Architectural Review Board Staff Report

Project Type: Amended Architectural Elevations

Description: **Chesterfield Village Mall (Watermark Residential) AAE:** Amended Architectural Elevations for a 12.96 acre tract of land zoned “R-8” Residence District with a Planned Environment Unit (PEU) procedure located southeast of the intersection of Chesterfield Parkway West and Lydia Hill Road.

BLDG-2 SOUTH ELEVATION

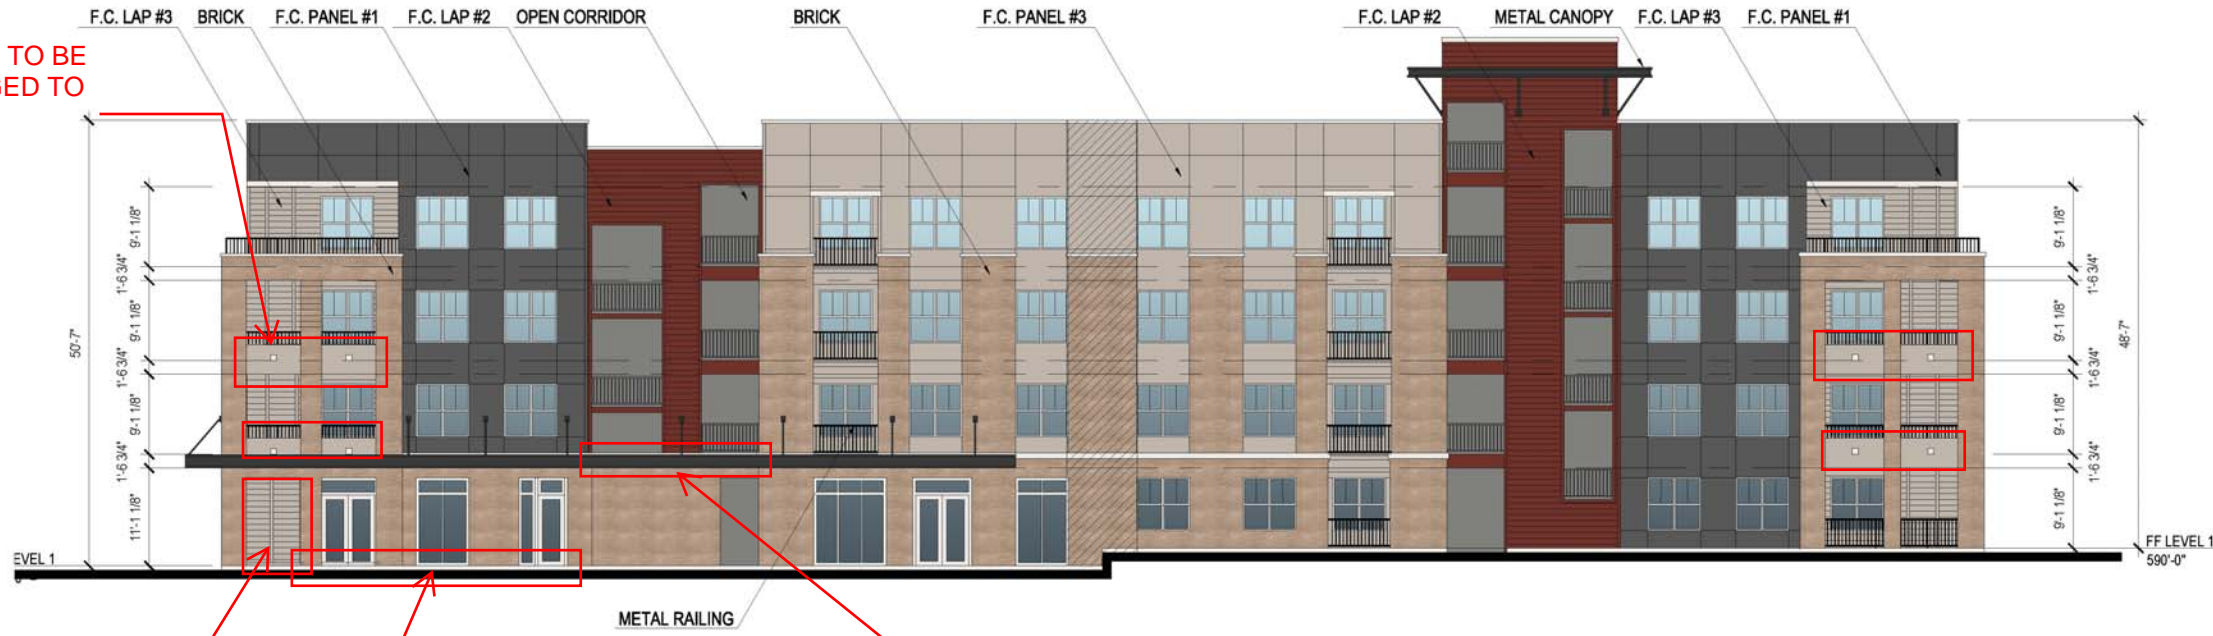
THESE SPANDRELS USED TO BE BRICK. RECENTLY CHANGED TO FIBER CEMENT PANELS

CANOPY OVER GARAGE ENTRIES WILL BE PROVIDED

BLDG 1 EAST ELEVATION

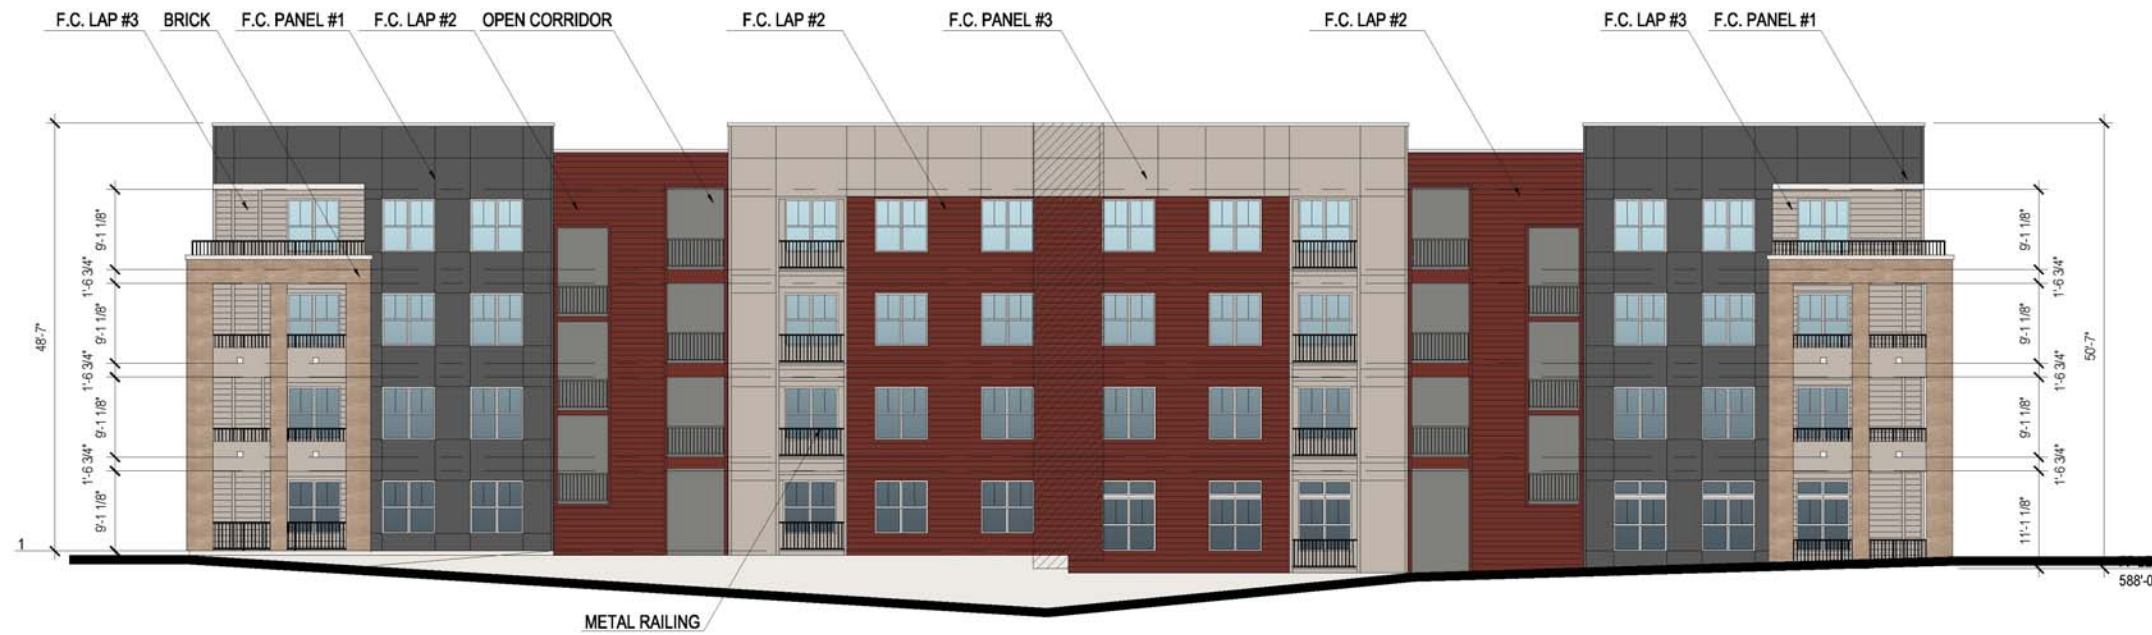
THESE SPANDRELS USED TO BE BRICK. RECENTLY CHANGED TO FIBER CEMENT PANELS

THIS WAS SHOWN AS A STOREFRONT WINDOW. A PATIO WAS ADDED TO BETTER FRONT THE CLUBHOUSE ENTRANCE PATH. THERE IS STILL A STOREFRONT WINDOW AROUND THIS SAME CORNER BUT ON A PERPENDICULAR WALL

STOREFRONT WAS EXTENDED UP TO THE FLOOR, PREVIOUS BASE WAS REMOVED

THIS CANOPY WAS EXTENDED TO BECOME A CONTINUOUS SPAN ALONG THE LENGTH OF THE CLUBHOUSE WALL

BLDG 1 SOUTH ELEVATION

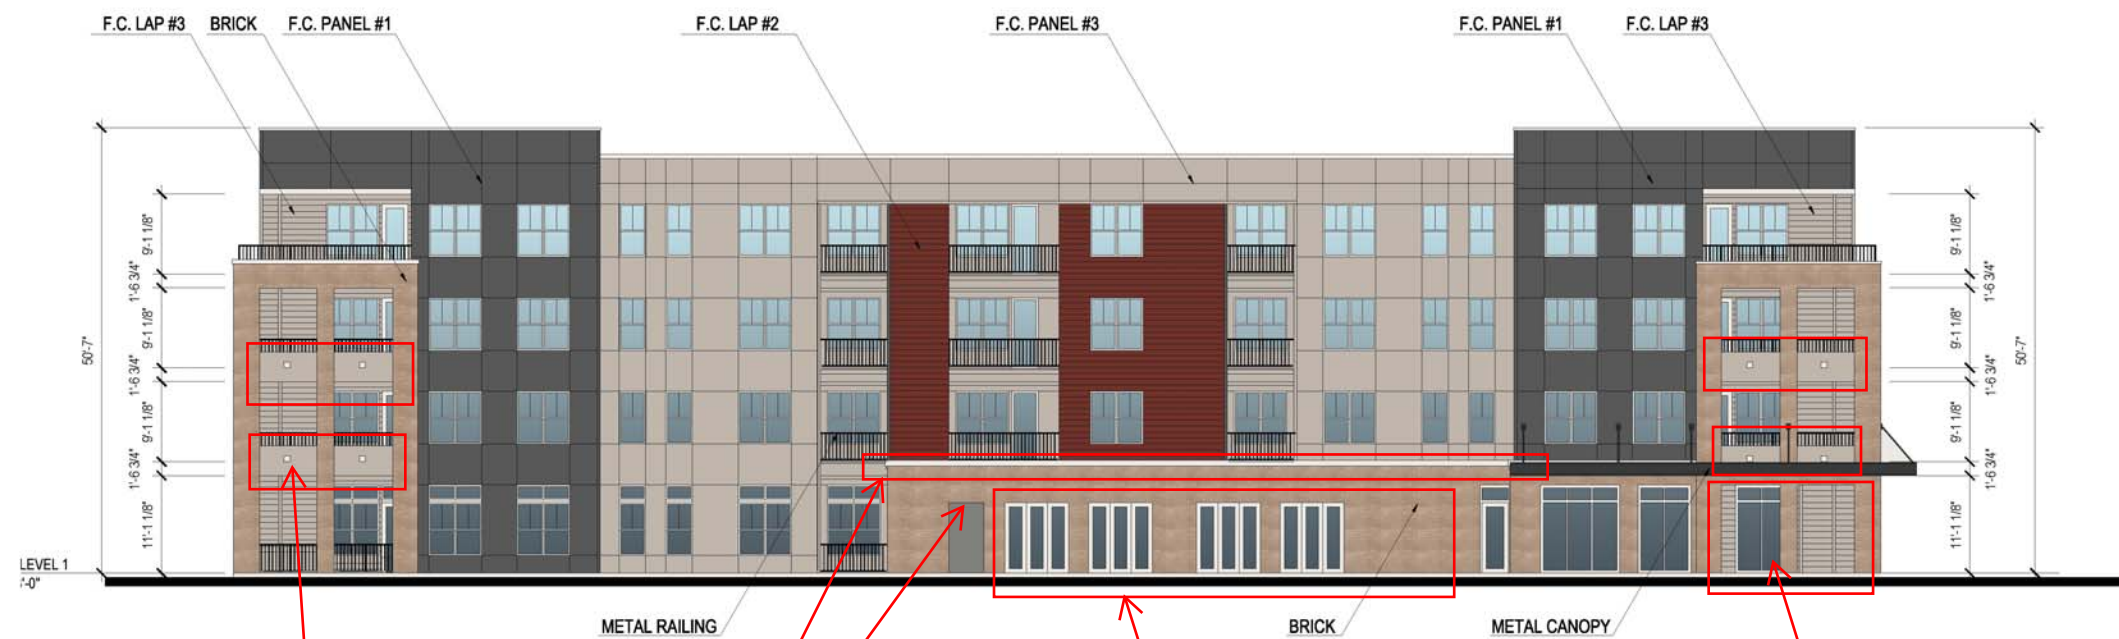
SC/ 0' THESE SPANDRELS USED TO BE BRICK. RECENTLY CHANGED TO FIBER CEMENT PANELS

CANOPY REMOVED CAST STONE REPLACED WITH BRICK

CANOPY REMOVED

STOREFRONTS WERE CHANGED TO 4 FOLDING WINDOW/DOOR SYSTEMS TO ENHANCE ACCESS TO COURTYARD

STOREFRONT WAS PUSHED BACK TO MAKE FOR A PATIO
